**I-405 MP 26.46 North Fork Perry Creek
(WDFW ID 08.0070 A 0.25):
Final Hydraulic Design Report – NDC 152**

Revision		Description
A	4/5/2024	Preliminary Submittal
B	8/25/2024	Final Submittal
0	4/9/2025	RFC Submittal
1	5/1/2026	NDC 152

This notice of design change (NDC) modifies the I-405 MP 26.46 North Fork Perry Creek Final Hydraulic Design Report (FHD). It presents updated bed material gradations and updated scour analyses associated with this change. This report addendum supersedes and replaces the following tables, sections, and figures as specified below.

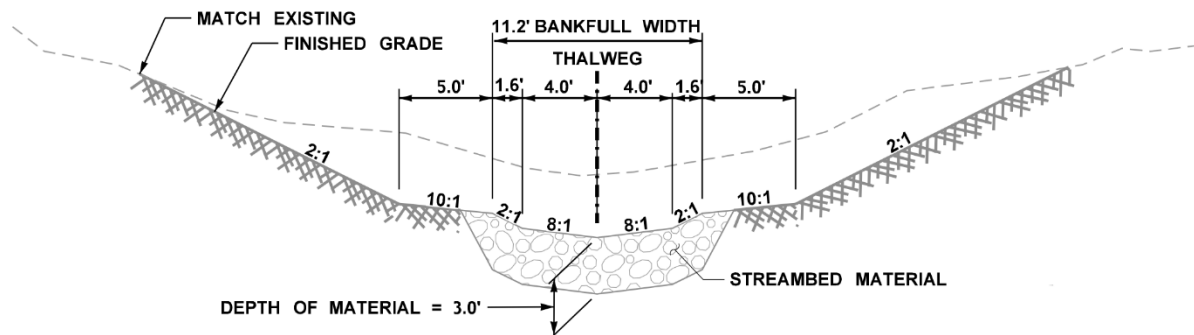
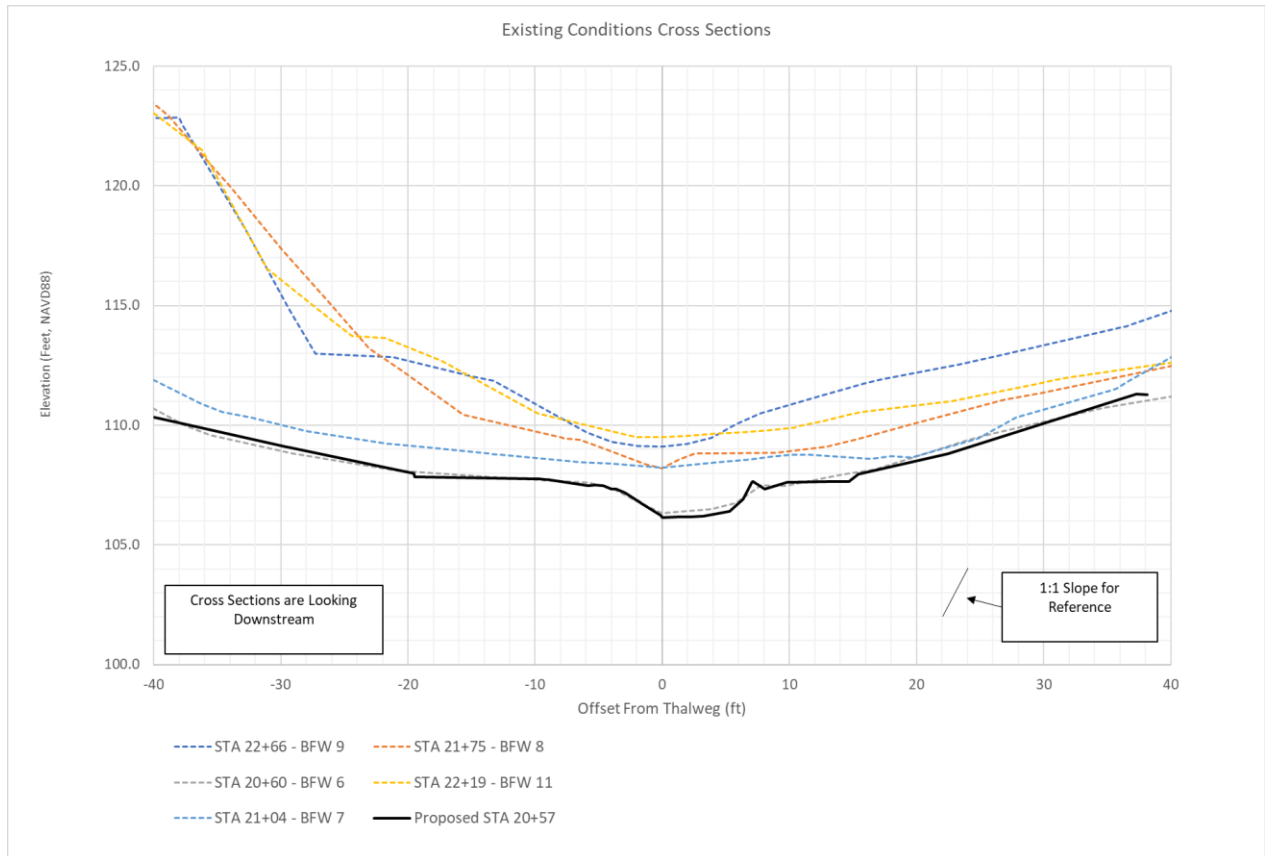
- Section 4.1.1 Channel Planform and Shape
 - Removed reference to previous Type I Streambed Material in text
 - Updated Figure 4-2 and Figure 4-3
- Section 4.2 Minimum Hydraulic Opening

Proposed cross slopes in riffles are 8H:1V to promote fish passage in low flows. Per stability recommendation from the geotechnical engineer, proposed riffle cross sections have 2H:1V bank slopes rising to the BFW of 11.2 feet (**Figure 4-2**).

Figure 4-4: Minimum hydraulic opening illustration

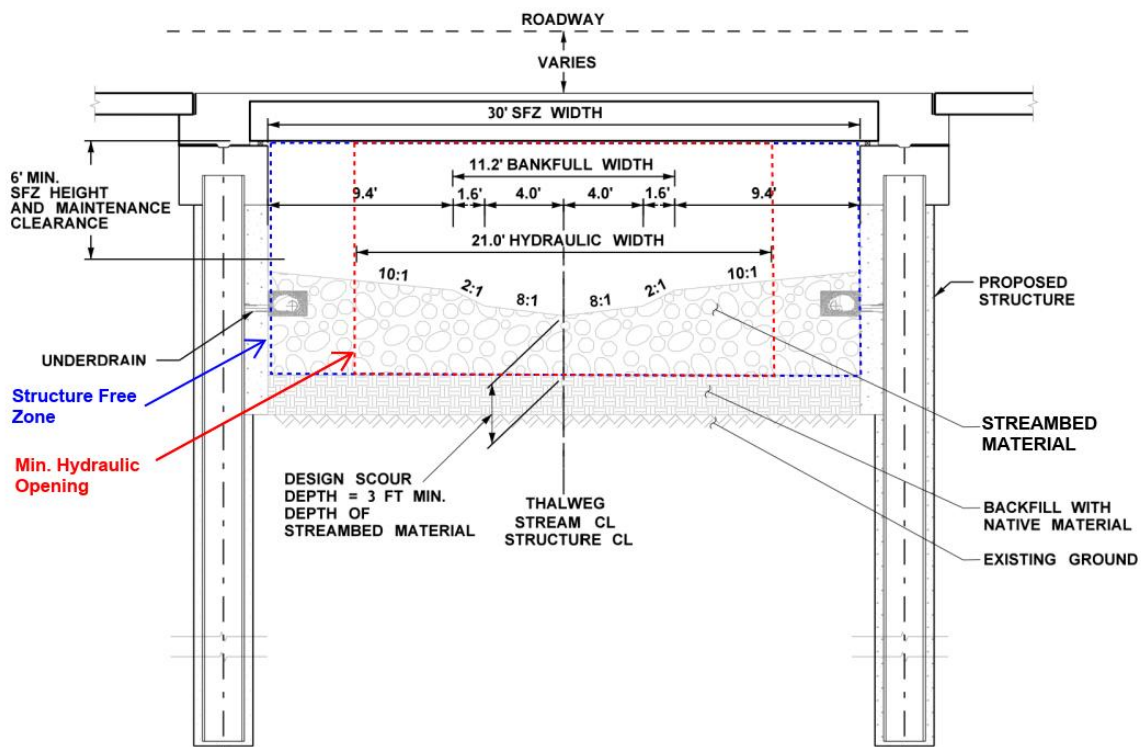
- Updated Figure 4-4
- Section 4.3.1 Bed Material
 - Updated discussion of streambed material gradations
 - Updated Table 4-1 and Table 4-2
 - Table 4-7 deleted
